MONTGOMERY COUNTY HISTORIC PRESERVATION COMMISSION
STAFF REPORT

Address:	10201 Menlo Ave.	Meeting Date:	10/25/17
Resource:	Contributing Resource Capitol View Historic District	Report Date:	10/18/17
Review:	HAWP	Public Notice:	10/11/17
Case Number:	31/07-17G	Tax Credit:	None
Applicant:	Minter Farnsworth	Staff:	Dan Bruechert
Proposal:	New Construction

Address:	10201 Menlo Ave.	Meeting Date:	10/25/17
Resource:	Contributing Resource Capitol View Historic District	Report Date:	10/18/17
Review:	HAWP	Public Notice:	10/11/17
Case Number:	31/07-17G	Tax Credit:	None
Applicant:	Minter Farnsworth	Staff:	Dan Bruechert
Proposal:	New Construction

SITE PLAN
1" = 20'

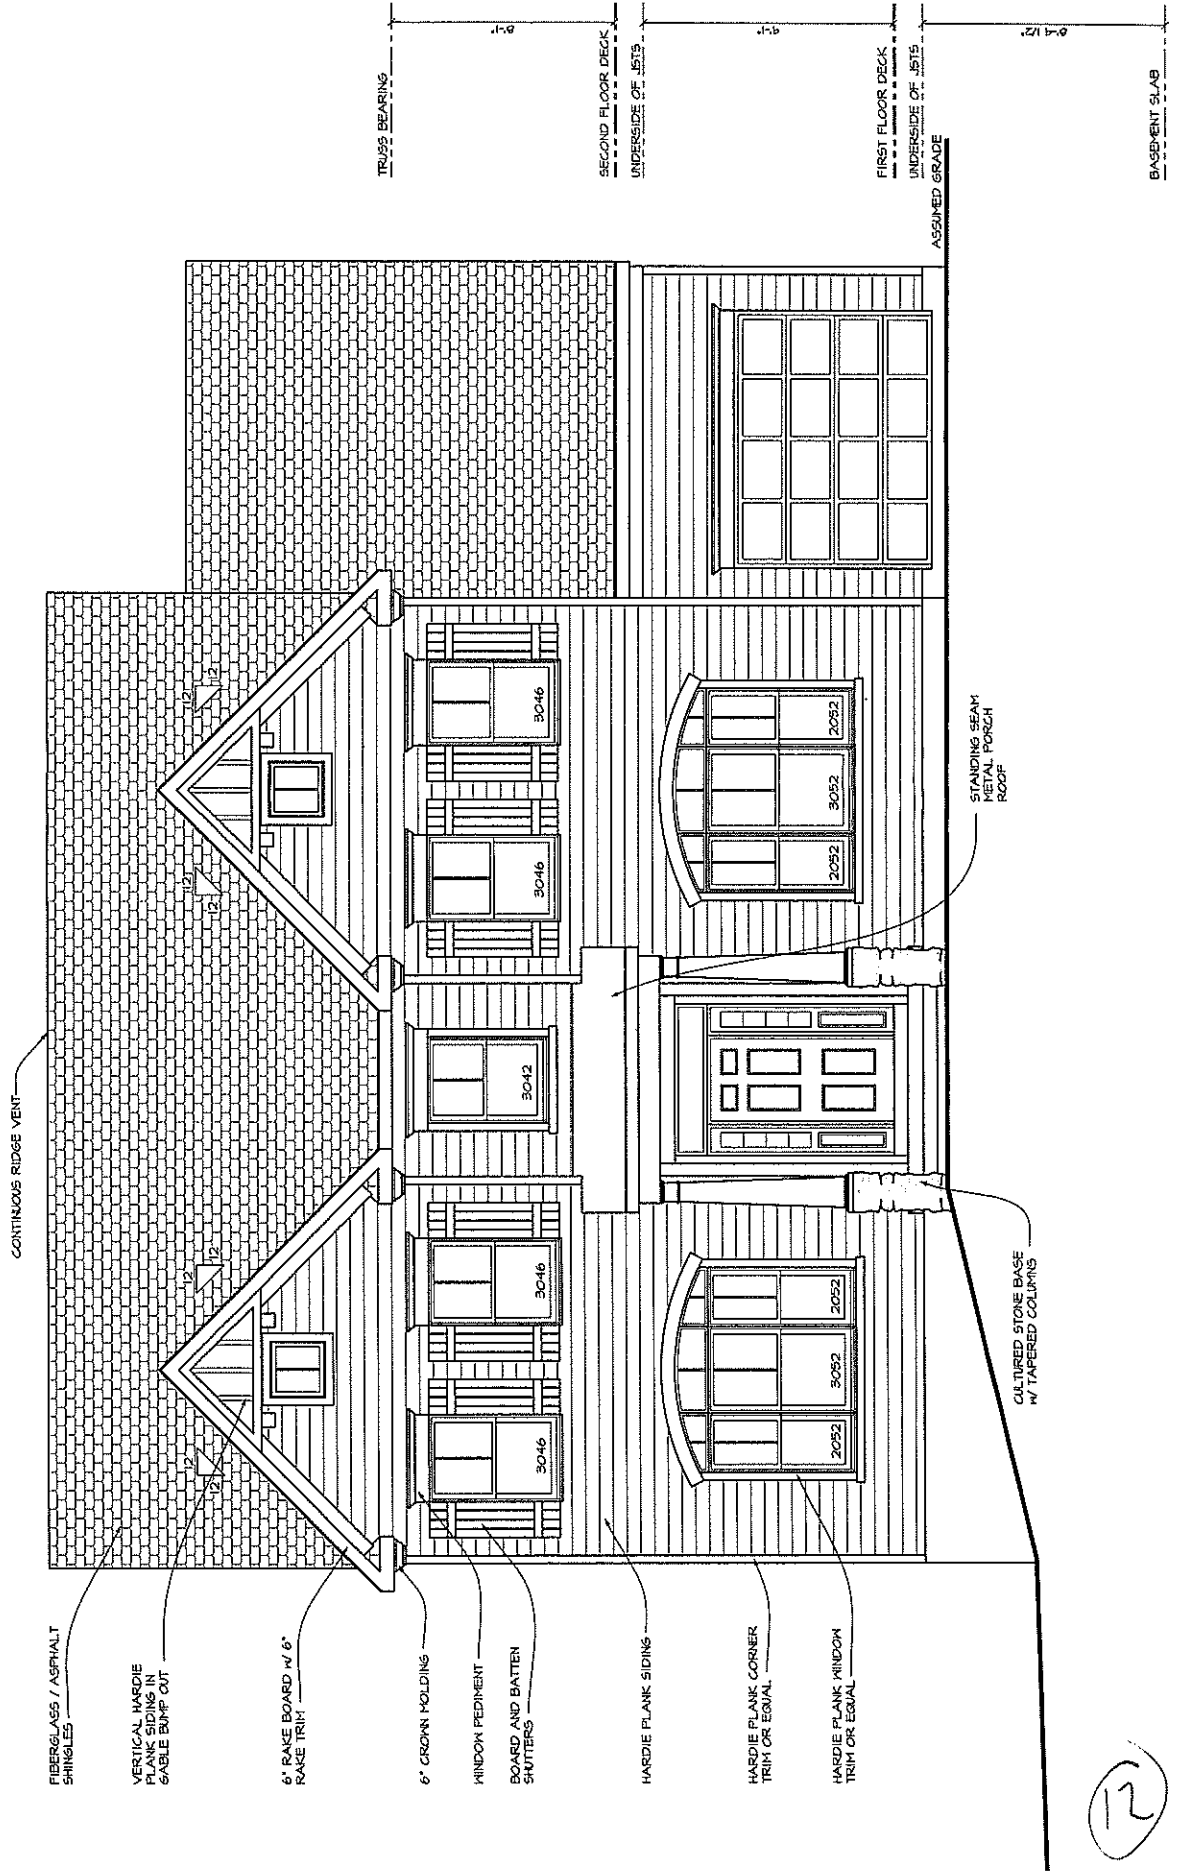
The applicant is proposing to install a six foot (6') tall, wood, board on board privacy fence placed at the front boundary of the property. The HPC does not typically approve fences taller than forty-eight inches (48") in front of the rear wall plan within historic districts. The neighboring property has a fence that is approximately five feet (5') tall, which would intersect the proposed fence at the middle. The southern half of the proposed fence will be obscured by the neighbors existing fence and will not be visible. The northern portion of the fence will be visible from the public right of way and staff believes that due to the unique siting of the lot, a solid board on board design is acceptable, however, the fence height should be reduced to 48" (forty-eight inches) to the north of the neighbor's wooden fence.

The applicant additionally is proposing to construct three sections of a retaining wall to be built out of 6" x 6" (six inches by six inches) railroad ties and will range from grade height to 30" (thirty inches) tall. Due to the negative slope of the lot, none of the retaining wall sections will be visible from the public right-of-way. Staff believes that this material is consistent with the retaining walls used throughout the district and is an acceptable material.

The applicant is proposing to install a six foot (6') tall, wood, board on board privacy fence placed at the front boundary of the property. The HPC does not typically approve fences taller than forty-eight inches (48") in front of the rear wall plan within historic districts. The neighboring property has a fence that is approximately five feet (5') tall, which would intersect the proposed fence at the middle. The southern half of the proposed fence will be obscured by the neighbors existing fence and will not be visible. The northern portion of the fence will be will be visible from the public right of way and staff believes that due to the unique siting of the lot, a solid board on board design is acceptable, however, the fence height should be reduced to 48" (forty-eight inches) to the north of the neighbor's wooden fence.

The applicant additionally is proposing to construct three sections of a retaining wall to be built out of 6" x 6" (six inches by six inches) railroad ties and will range from grade height to 30" (thirty inches) tall. Due to the negative slope of the lot, none of the retaining wall sections will be visible from the public right-of-way. Staff believes that this material is consistent with the retaining walls used throughout the district and is an acceptable material.

1. The windows must be either wood or clad, not vinyl, and have fixed interior and exterior grids. Details need to be submitted to Staff for review and approval with final approval authority delegated to staff.
2. The proposed fencing must be lowered to no higher than 48" (forty-eight inches) above grade north of the neighbors existing privacy fence.
3. Due to the site's environmentally sensitive location an erosion plan must be submitted for review and approval with final authority delegated to staff.

1. The windows must be either wood or clad, not vinyl, and have fixed interior and exterior grids. Details need to be submitted to Staff for review and approval with final approval authority delegated to staff.
2. The proposed fencing must be lowered to no higher than 48" (forty-eight inches) above grade north of the neighbors existing privacy fence.
3. Due to the site's environmentally sensitive location an erosion plan must be submitted for review and approval with final authority delegated to staff.

FRONT ELEVATION 1/4" = 1'

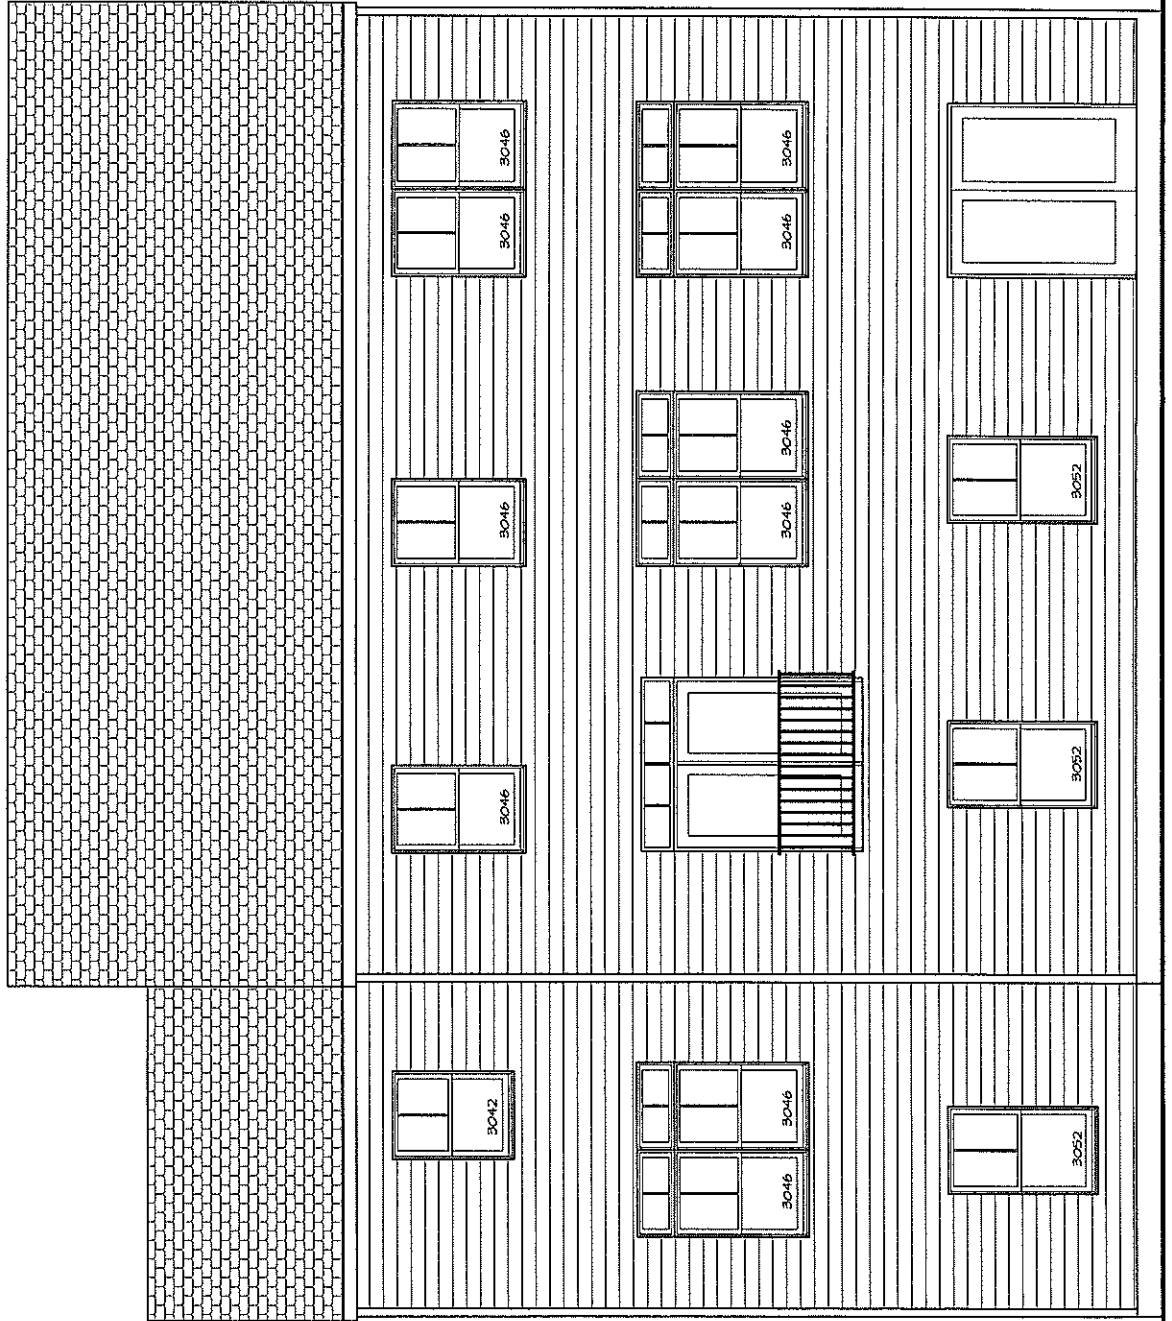
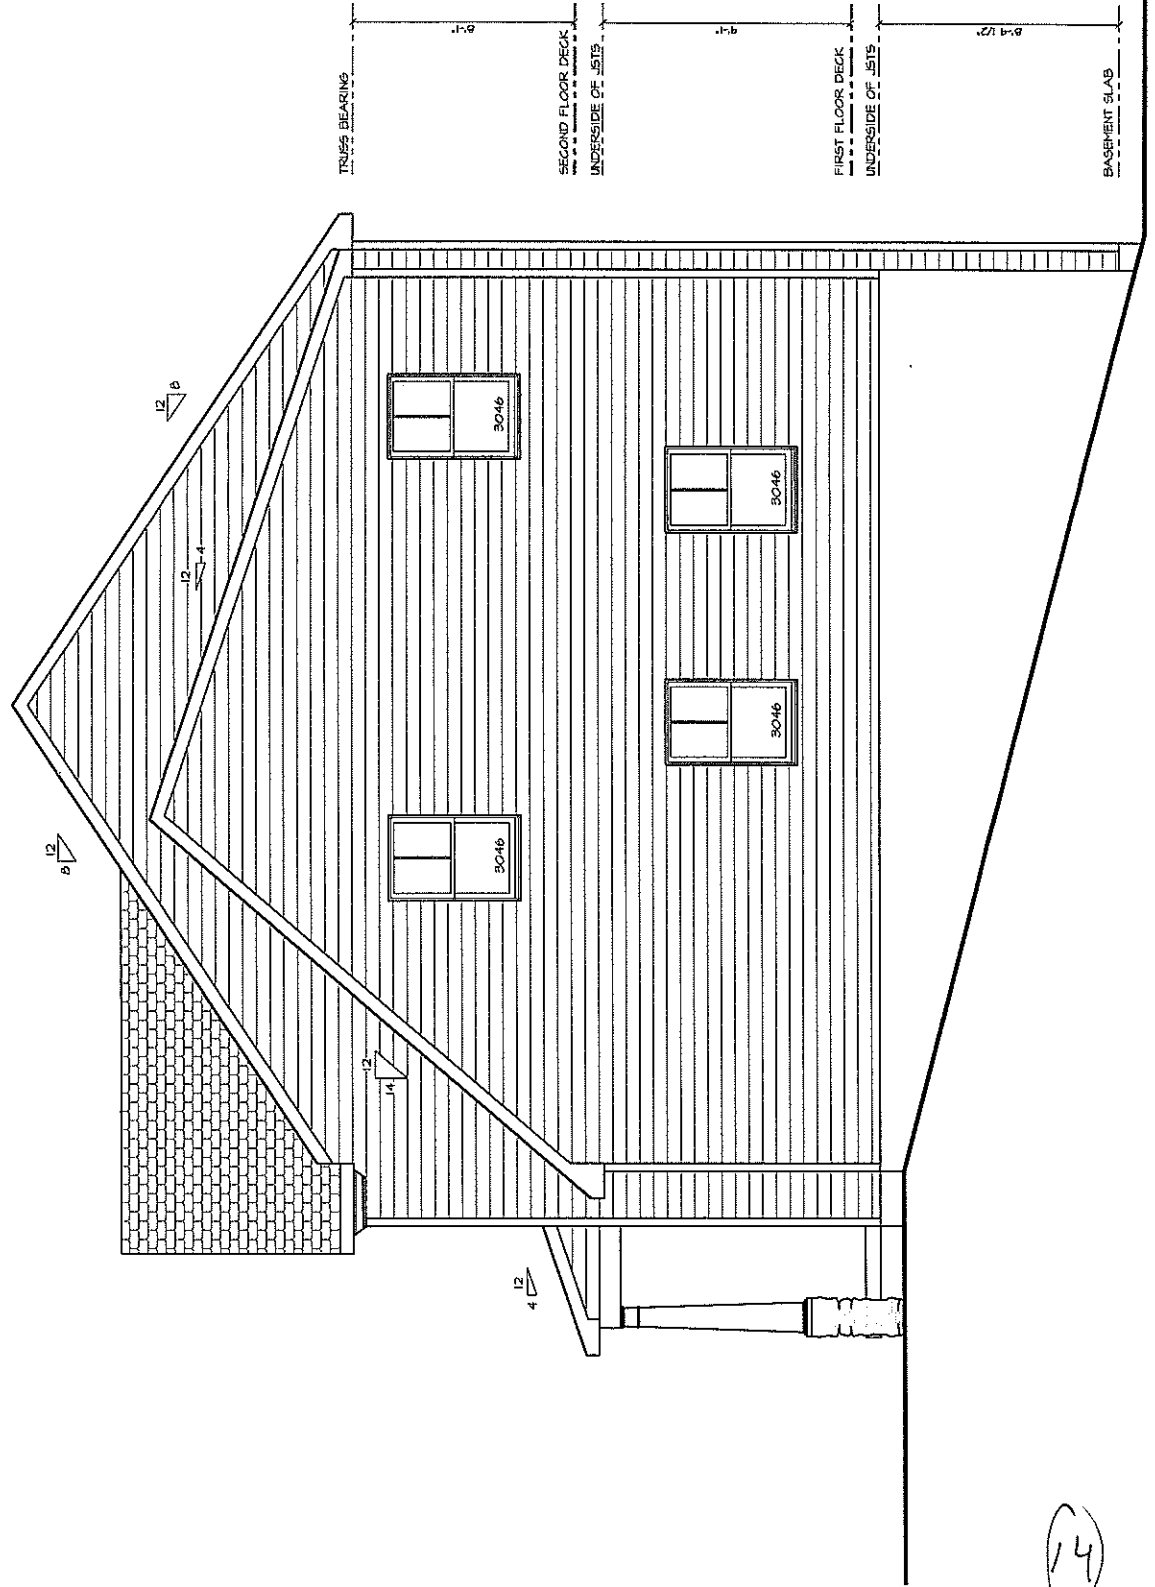
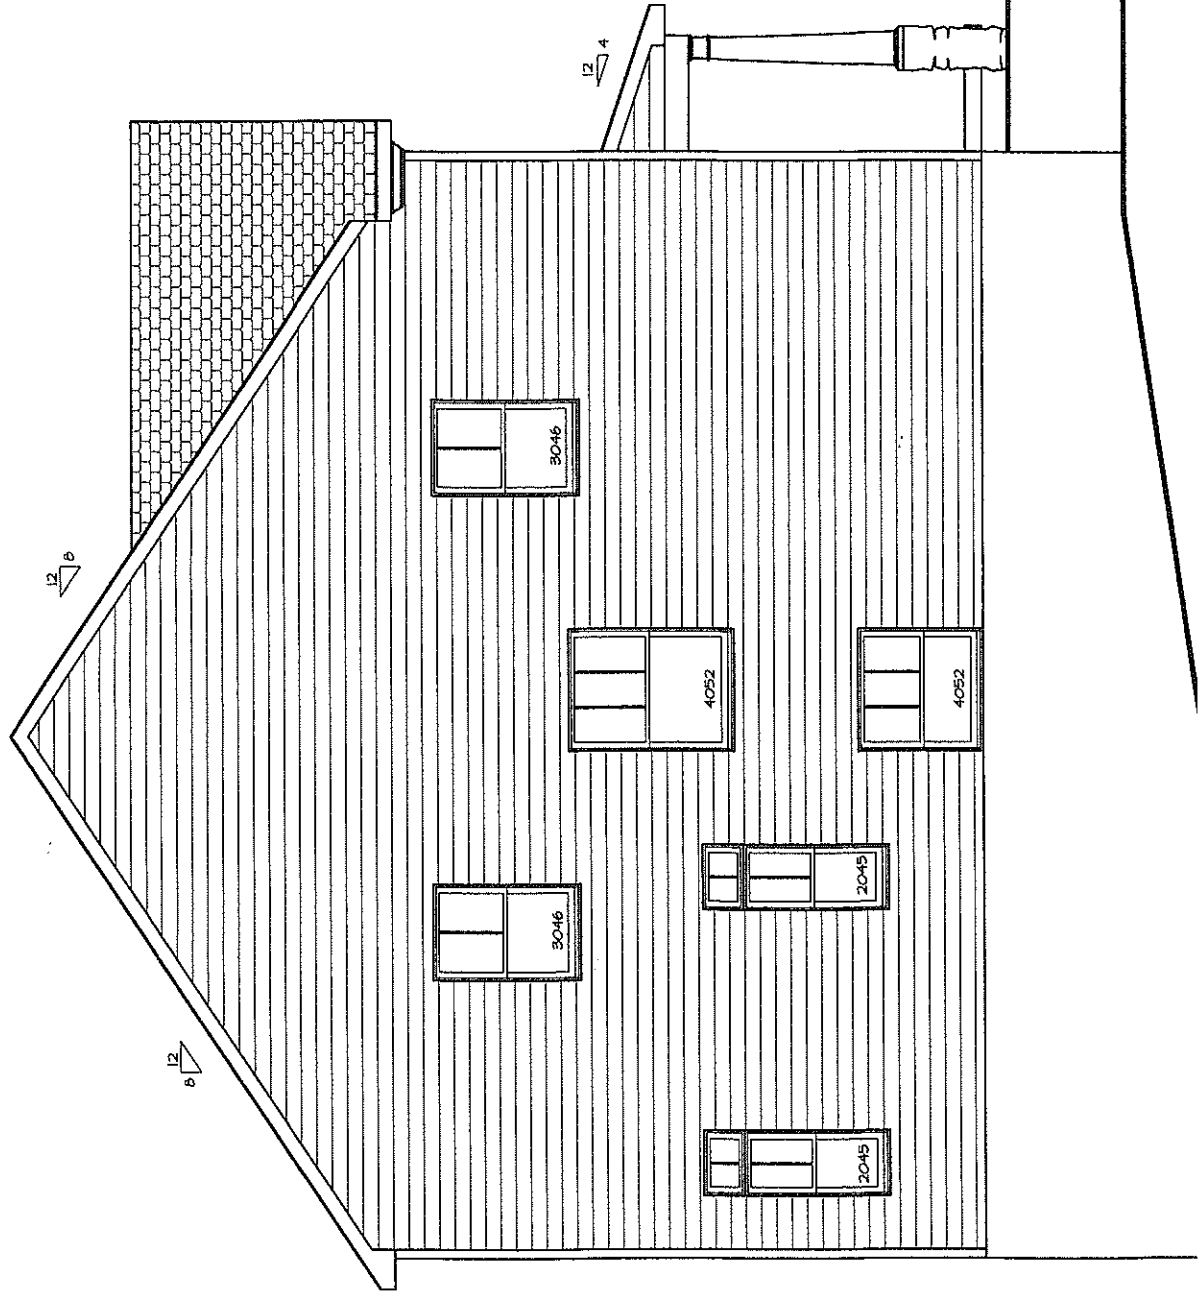
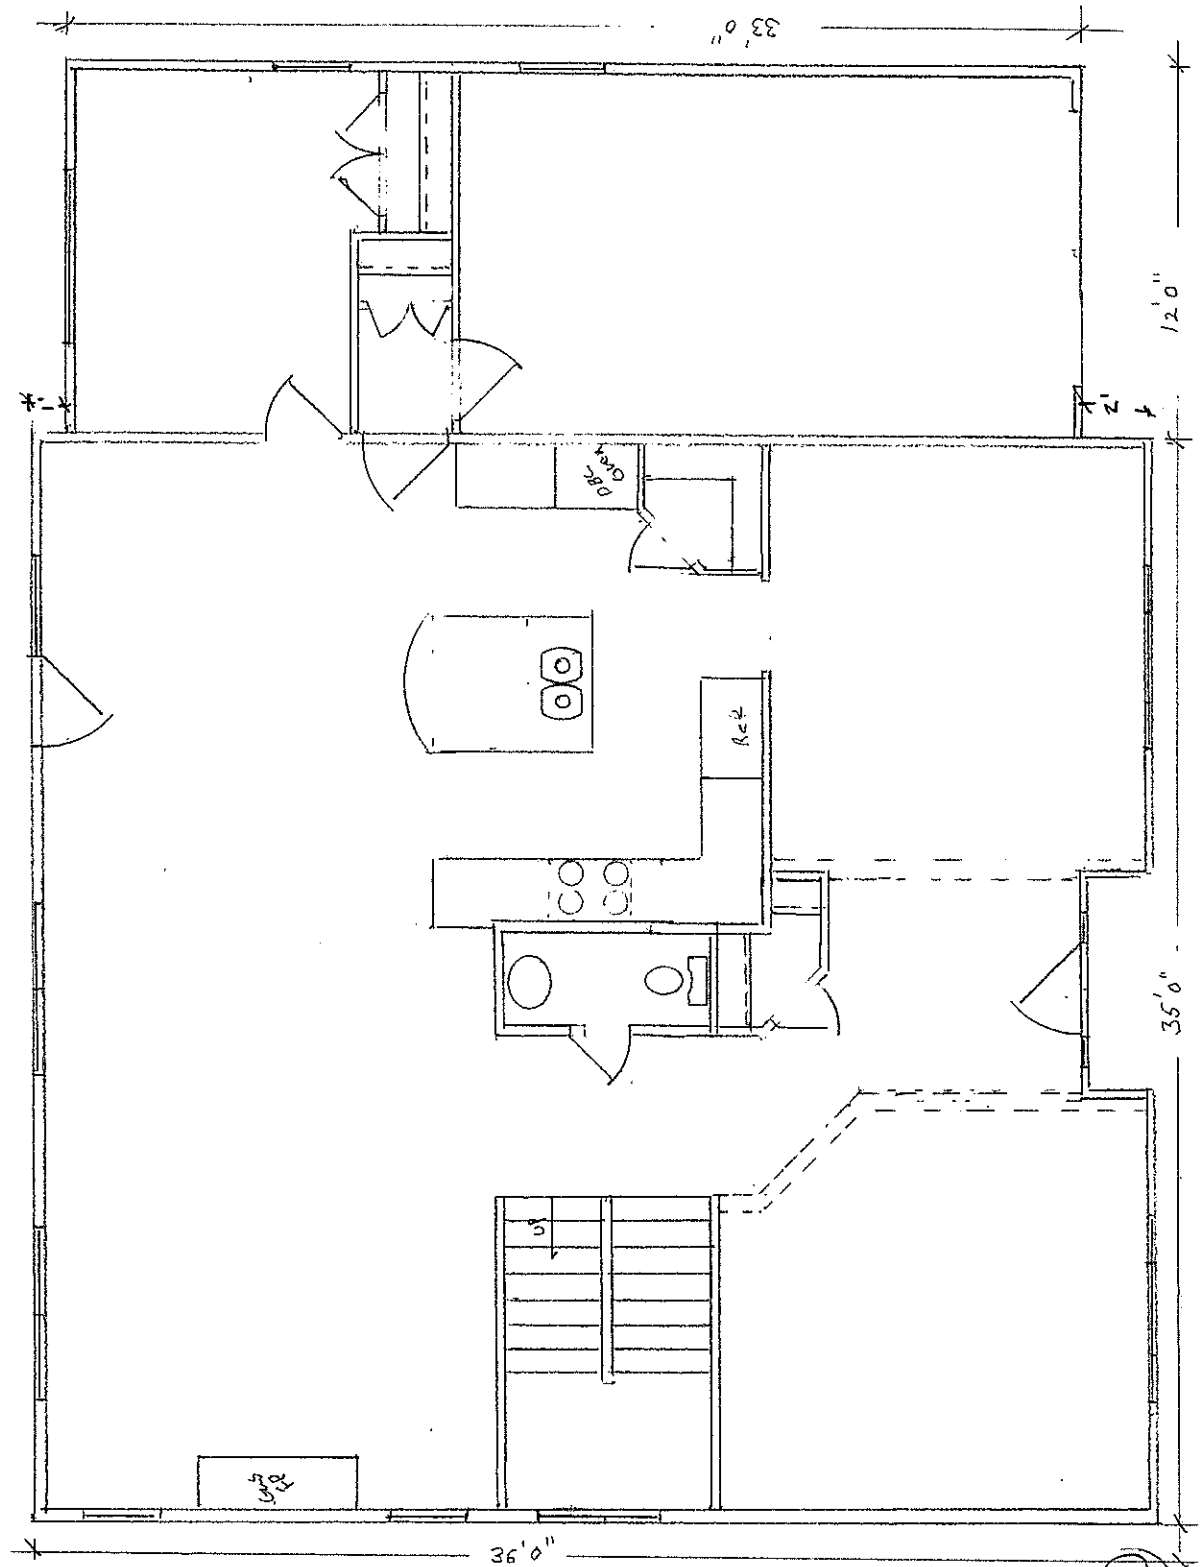
The applicant proposes to construct a new two-story, side gable house, three bays wide, with Hardi siding on the lot. The house has two smaller front facing gables and a small covered front porch. To the right there is a single bay attached garage covered in a gable roof.

The style of the house is best described as “Traditional” as it draws from several different periods of construction. The two-over-one windows are more in keeping with a Craftsman house as are the battered columns covering the front porch. The board and batten shutters and board and batten decoration under the two front facing gables are more vernacular elements. At the rear there are some two-over-one windows that have a two-lite transom above. The applicant proposes an uncovered deck to the rear.

The applicant did not provide windows specifications with the application materials. Staff thinks that the proposed two-over-one configuration is acceptable, and recommends the HPC condition approval on the applicant using a wood or clad window using either true divided lites or simulated divided lites with fixed interior and exterior grids.

The applicant did not provide windows specifications with the application materials. Staff thinks that the proposed two-over-one configuration is acceptable, and recommends the HPC condition approval on the applicant using a wood or clad window using either true divided lites or simulated divided lites with fixed interior and exterior grids.
